February 10, 2020

Re: Site C Clean Energy Project - Proposed Design Changes to Highway 29 Crossings at Farrell Creek, Dry Creek and Lynx Creek

Table 1. Proposed Revisions to EIS Section 4.3.4.1, Table 4.5

Figure 3: General arrangement of Highway 29 realignment segment at Dry Creek, per proposed revised bridge design (proposed Figure 4.29 Rev 1)

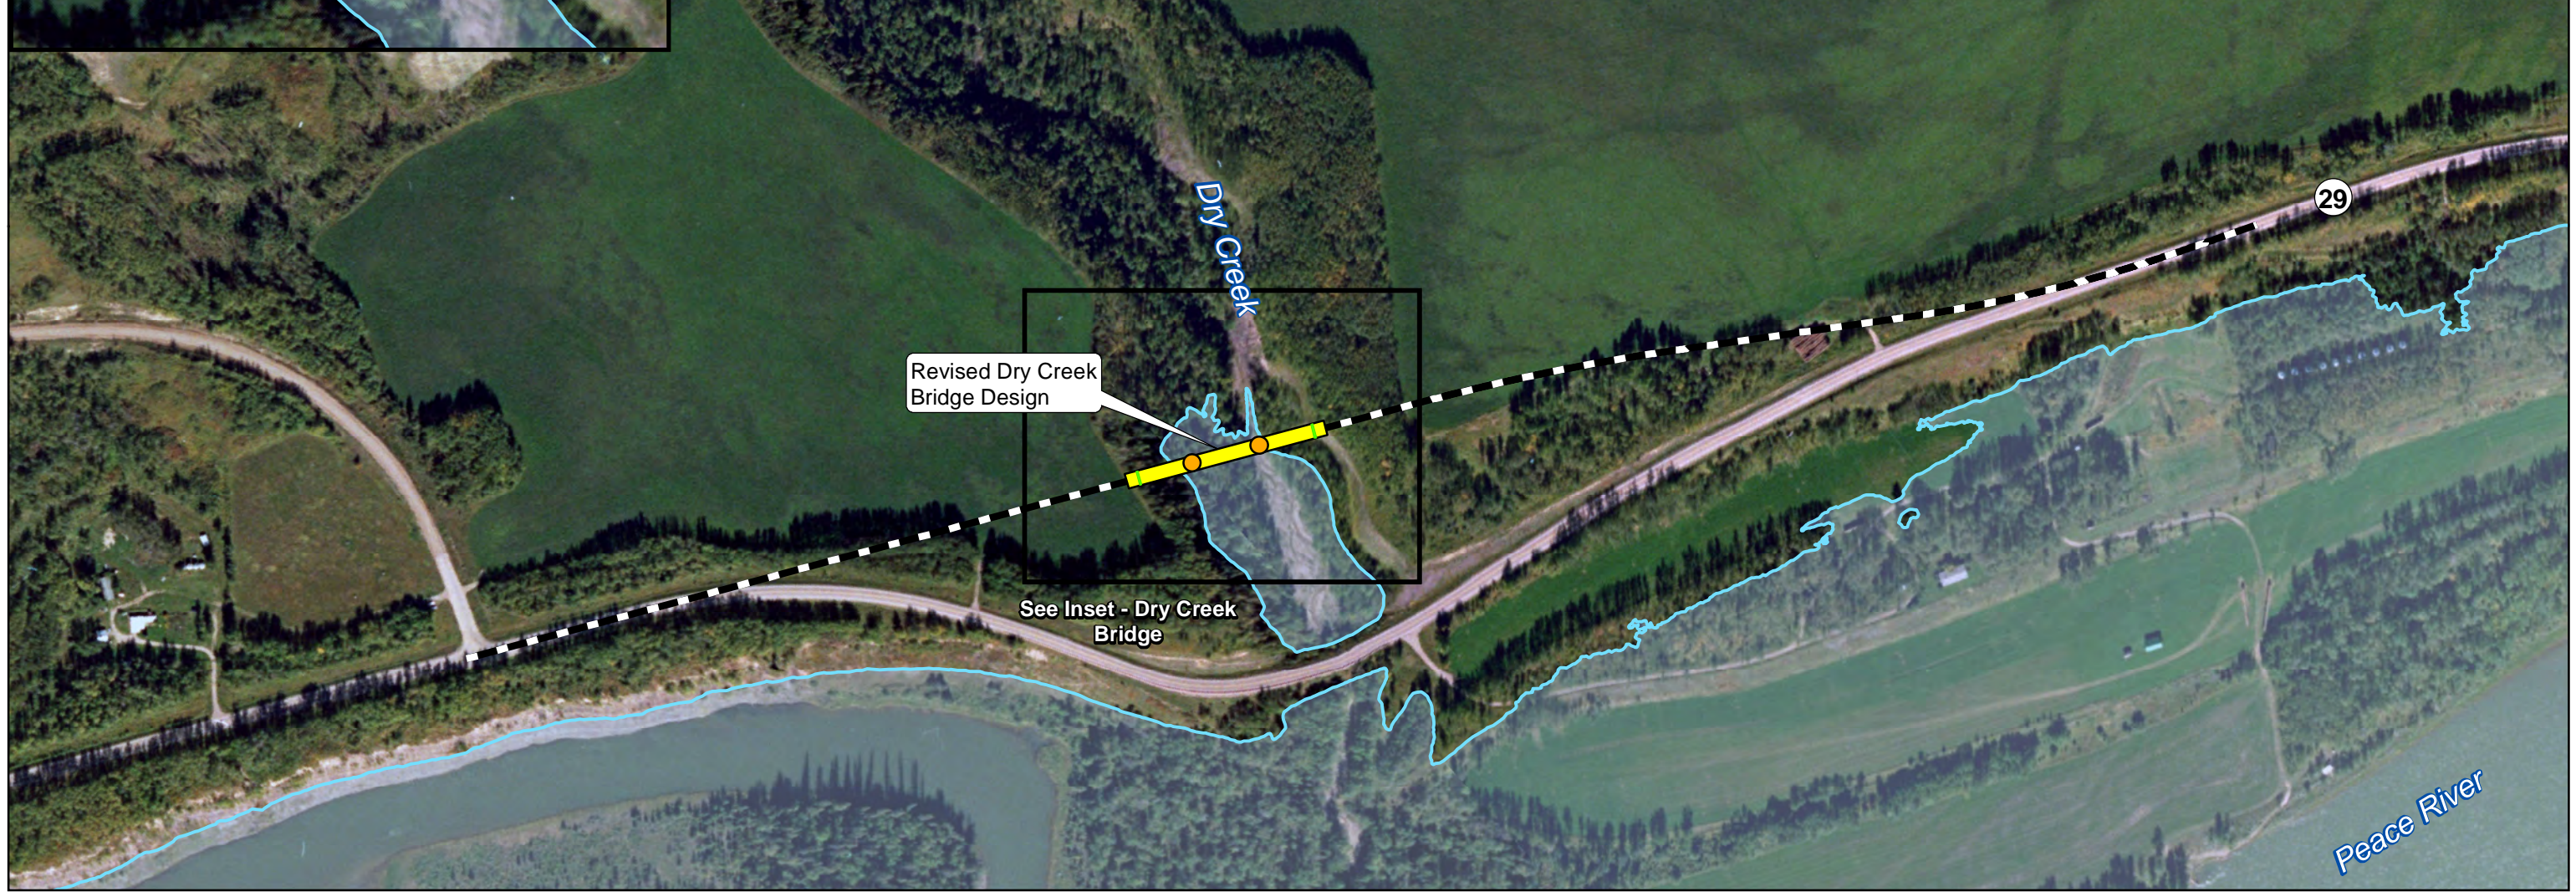
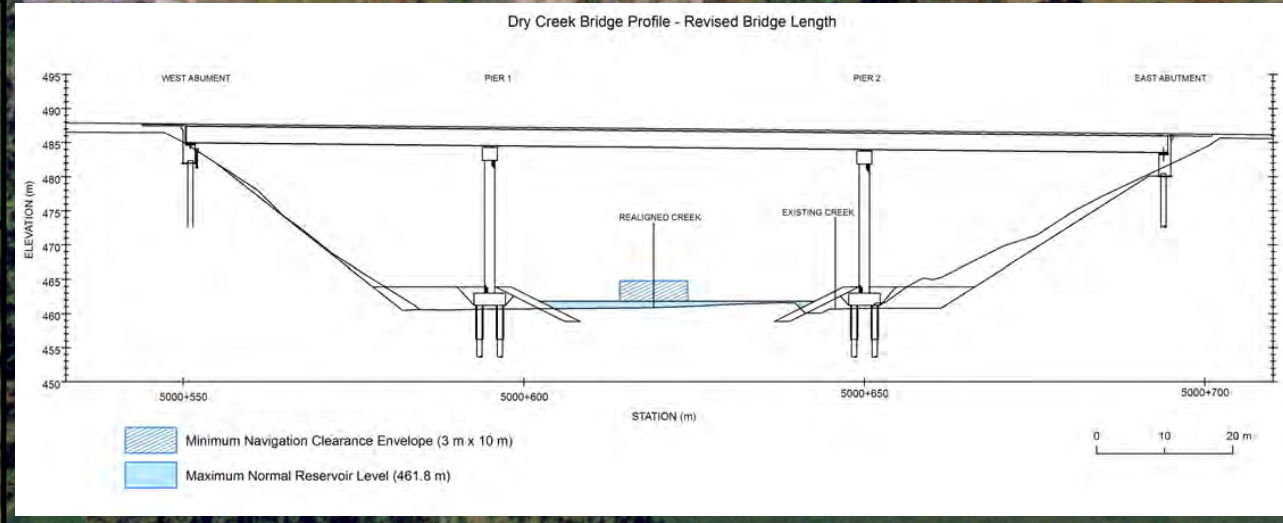
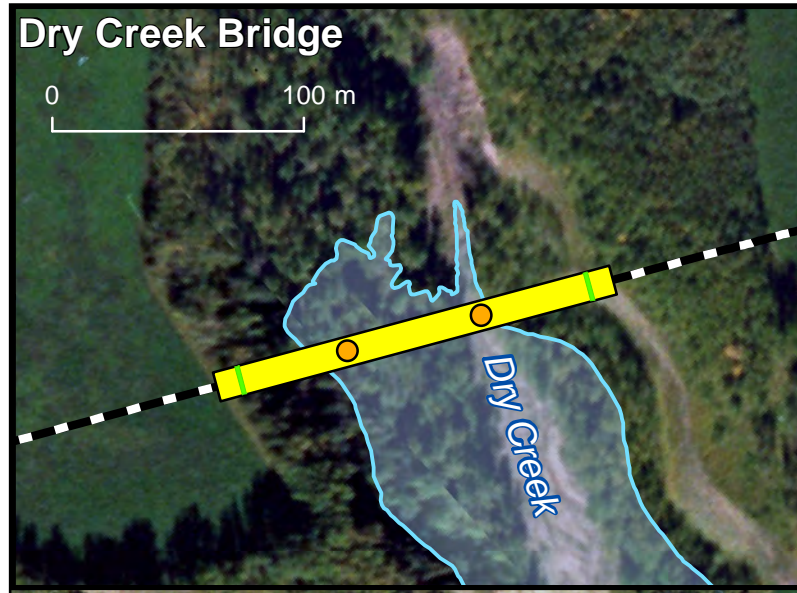
For the Highway 29 crossing at Dry Creek, BC Hydro is proposing to replace the culvert described in the EIS with a bridge that will be up to 200m long. BC Hydro is therefore proposing the following revisions to EIS Section 4.3.4.1, Table 4.5:

The proposed revised crossing alignment is located at its widest point approximately 85m to the north of the EIS alignment. Much of the proposed revised crossing location is within the area of disturbance assessed for the EIS. However, as described below, temporary containment berms will be required to isolate Dry Creek from the bridge pier footing sites. These containment berms will extend north of the area of disturbance as assessed in the EIS, and have been considered in the evaluation of impacts of the proposed revised design on valued components.

Component	EIS Text	Proposed Revisions to EIS Text
Highway 29 Realignment Dry Creek	Section 4.3.4.1, Table 4.5: Highway 29 Realignment Segments and Respective Watercourse Crossing Lengths For Dry Creek: Total Length of Segment: 1.5 km Causeway Length: N/A* Bridge Length: 11 m pipe-arch culvert Number of Piers: N/A Number of Bridge Spans: N/A Figure Number: Figure 4.29 Rev 0 (attached as Appendix B, Figure 2)	Section 4.3.4.1, Table 4.5: Highway 29 Realignment Segments and Respective Watercourse Crossing Lengths For Dry Creek: Total Length of Segment: 1.5 km Causeway Length: 0 m Bridge Length: up to 200 m Number of Piers: up to 3 Number of Bridge Spans: up to 4 Figure Number: Figure 4.29 Rev 1 (attached as Appendix B, Figure 3)

Figure 5: Profile of Dry Creek Crossing, per proposed revised design (not to scale)

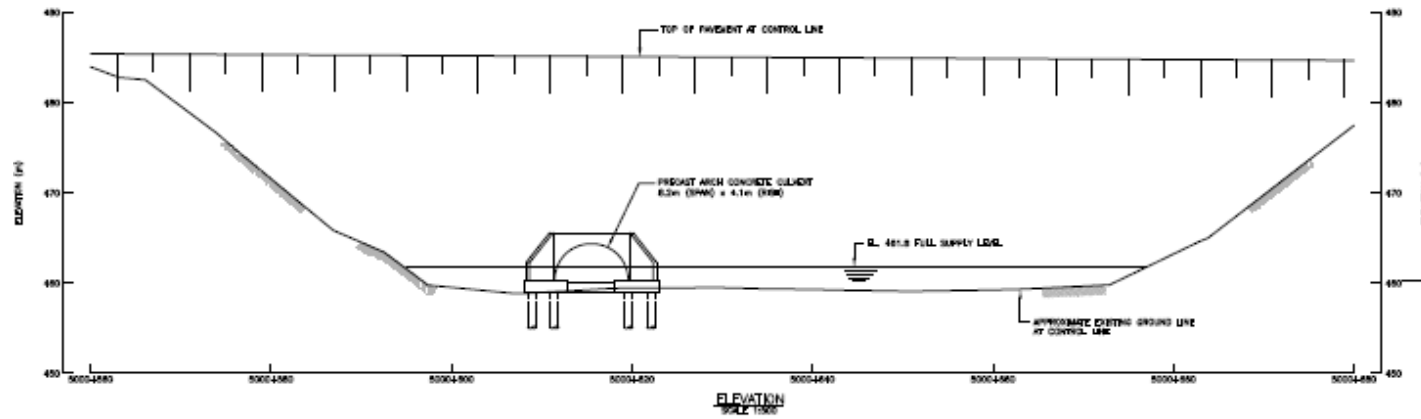
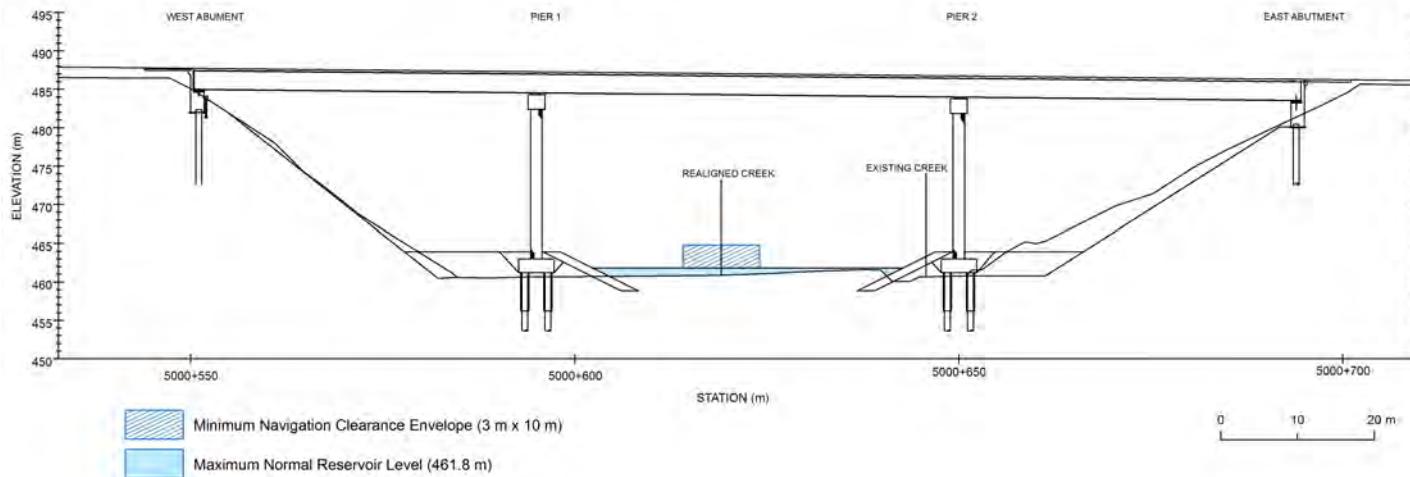
The assessment is supported by information in Figures 4 and 5 – the EIS Culvert and Revised Design Bridge profiles -- and Figure 6, a plan view of the EIS culvert design versus the proposed revised bridge design, post reservoir filling.

The proposed revised bridge design would have a clearance envelope that is 3m high, 10m wide in accordance with a memo sent to Transport Canada regarding Highway 29 bridge crossings.⁷ Based on the water depths and minimal wetted area upstream of this crossing as well as the navigation clearance envelope, the proposed revisions at the Dry Creek Highway 29 crossing is not expected to result in reductions in boater access or navigation.

Figure 6: Dry Creek Crossing - EIS Design vs Revised Design

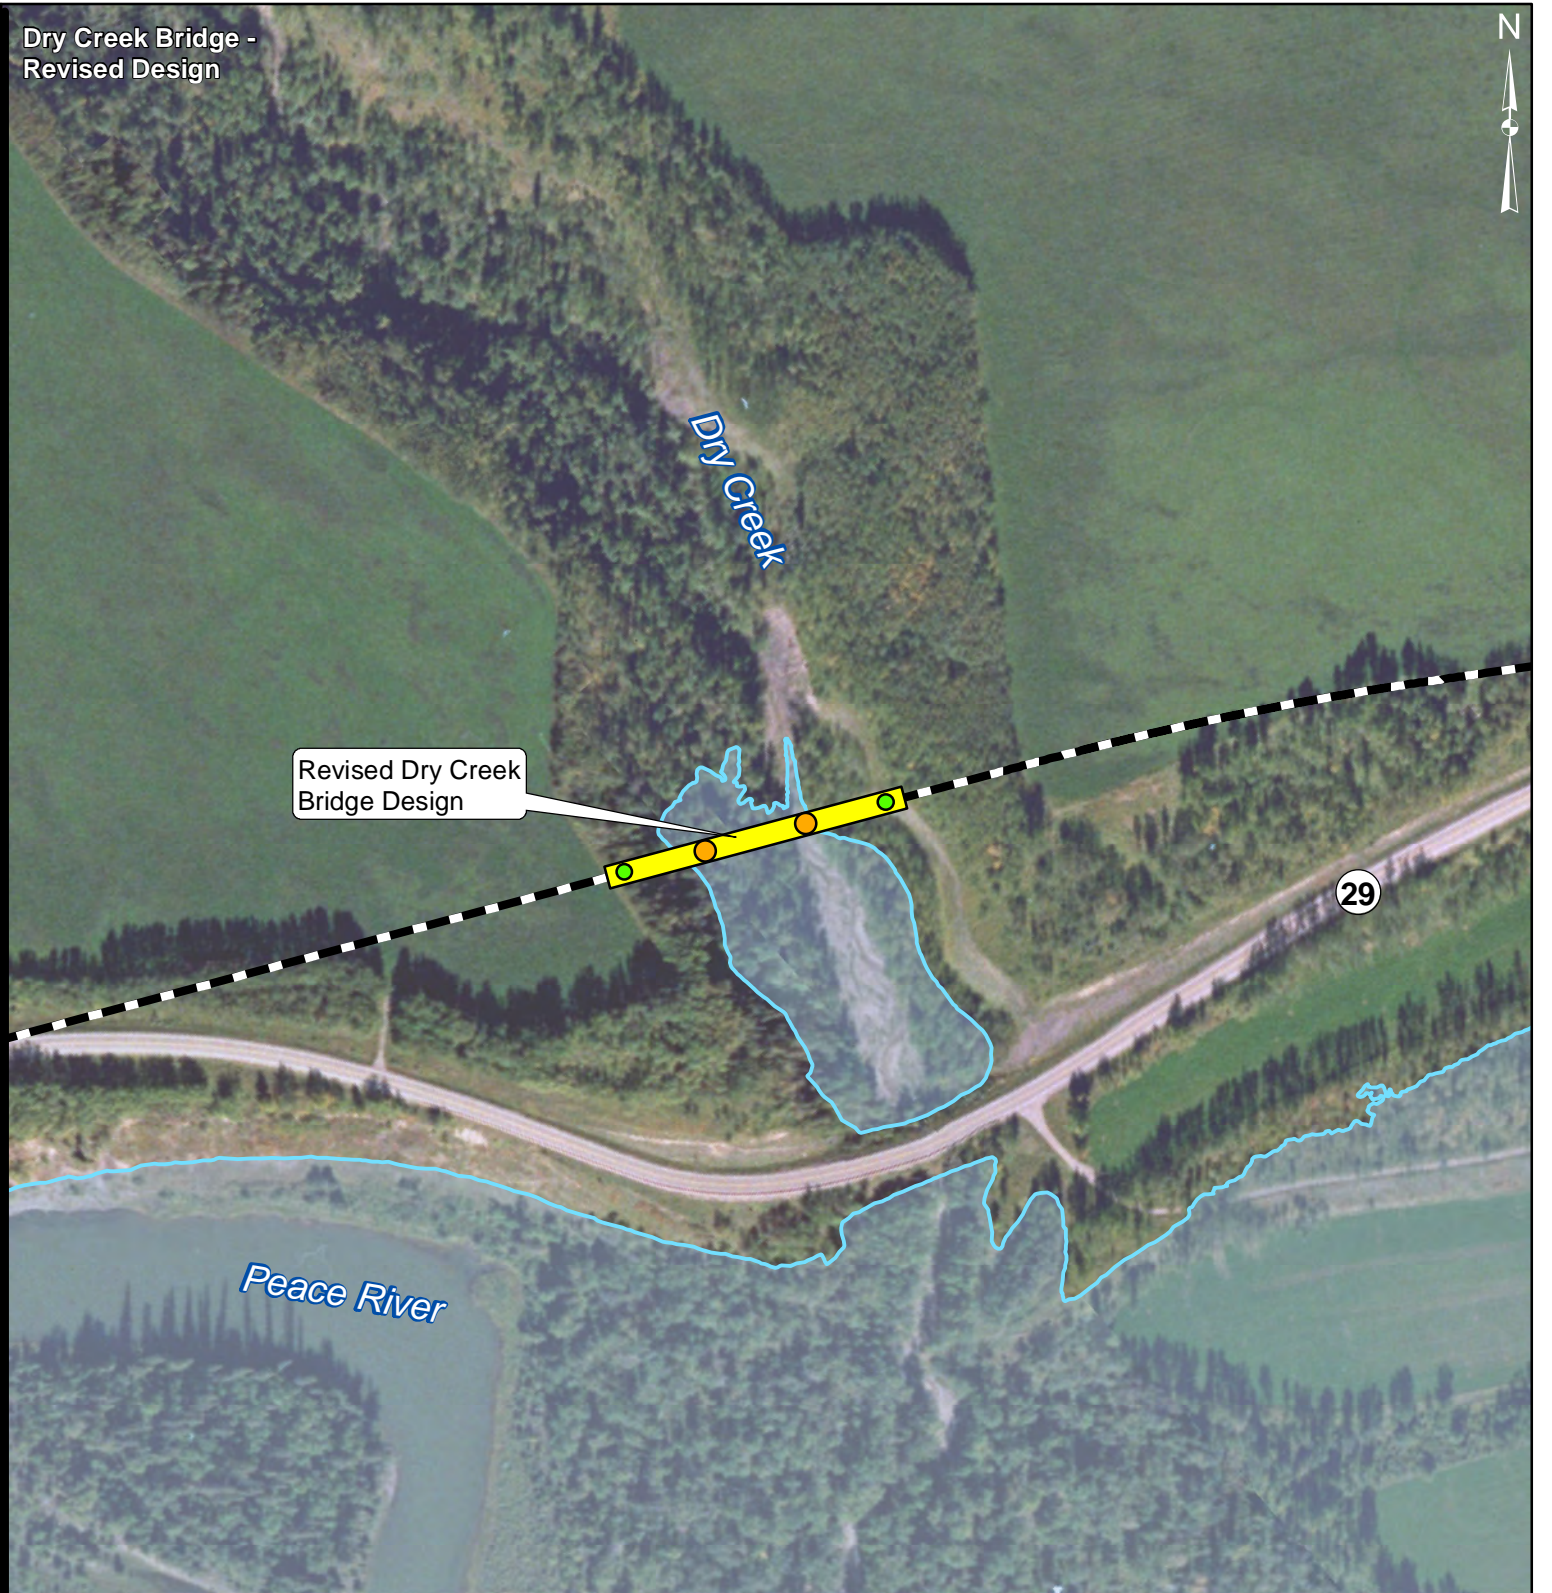
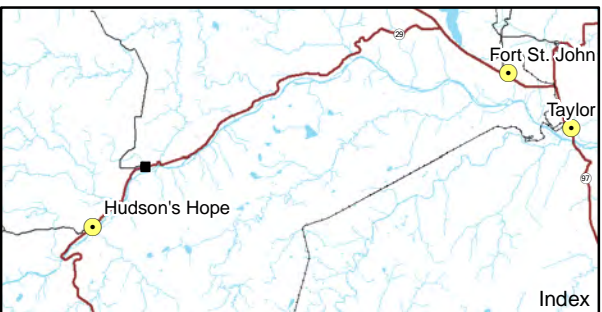
converted from stream to reservoir habitat following reservoir filling. The culvert (11m pipe-arch) and surrounding infill area in the EIS design would have encroached on a substantial portion of the present creek channel and blocked aerial input of food and nutrients from above the channel. The revised design includes a pier and diversion berm in the present channel, but the elimination of the culvert infill area will result in an overall reduced aquatic footprint.
